Access Compliance Report Public Rights-of-Way (Curb Ramps)

Intersection ID: 31208 Main Street: CLACKWYCK_LN Cross Street: GOODLOE_DR Location: W

ADA ID: 5C4A6FFD43B2 Ramp Type: PerpDiag Initial Pass/Fail: Fail Overall Compliance: No Severity Score: 22.5

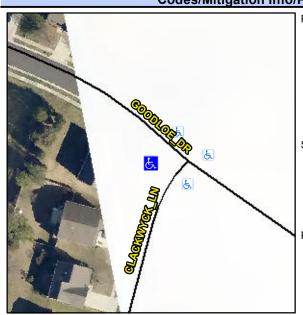
CLACKWYCK LN StopSign GOODLOE DR None Possible Solutions:
Remove & Replace Curb Ramp With Two New Directional Ramps or Equivalent.

PROW/ADA:
Not Found, R304.5.1, R304.2.2, R304.5.3

Field Measurements/Component Compliance					
Compliance Description		Data	Comp	liance Description	Data
N/A	Ramp Length (in)	45.0	No	Ramp Slope (%)	9.1
No	Ramp Width (in)	47.0	No	Ramp XSlope (%)	4.8
N/A	Flare Type LT	N/A	N/A	Flare Type RT	N/A
N/A	Flare Slope LT (%)	N/A	N/A	Flare Slope RT (%)	N/A
N/A	Flare Traversable LT?	N/A	N/A	Flare Traversable RT?	N/A
N/A	Landing Length (in)	N/A	N/A	DWS Provided?	N/A
N/A	Landing Width (in)	N/A	N/A	DWS Contrast?	N/A
N/A	Landing Slope (%)	N/A	N/A	DWS Length (in)	N/A
N/A	Landing X Slope (%)	N/A	N/A	DWS Full Width?	N/A
N/A	Landing Curb? (Y/N)	N/A	N/A	DWS Offset (in)	N/A
N/A	Shared Landing?	N/A			
N/A	Gutter Ponding?	N/A	N/A	Gutter Slope (%)	N/A
N/A	Gutter Lip Ht (in)	N/A	N/A	Gutter X Slope (%)	N/A
N/A	Painted X Walk1?	No	N/A	Painted X Walk2?	No
	X Walk 1 Direction	To SE		X Walk 2 Direction	To NE
N/A	X Walk 1 Width (in)	N/A	N/A	X Walk 2 Width (in)	N/A
	X Walk 1 Slope (%)	3.7		X Walk 2 Slope (%)	2.5

X Walk 1 X Slope (%)	1.2		X Walk 2 X Slope (%)	6.6
N/A	Ramp inside XWalk1?	N/A	N/A	Ramp inside XWalk2?	N/A
	Road Slope (%)	0.8	N/A	Clear Space?	N/A
	Road X Slope (%)	1.7	N/A	Clear Space to XWalk (in)	N/A
N/A	Any Obstructions?	N/A	N/A	Storm Grate/Utility Hazard?	N/A
	Obstruction Type		l	Storm Grate/Utility Type	
		N/A			N/A
			Yes	Surface Condition? (G/P)	Good
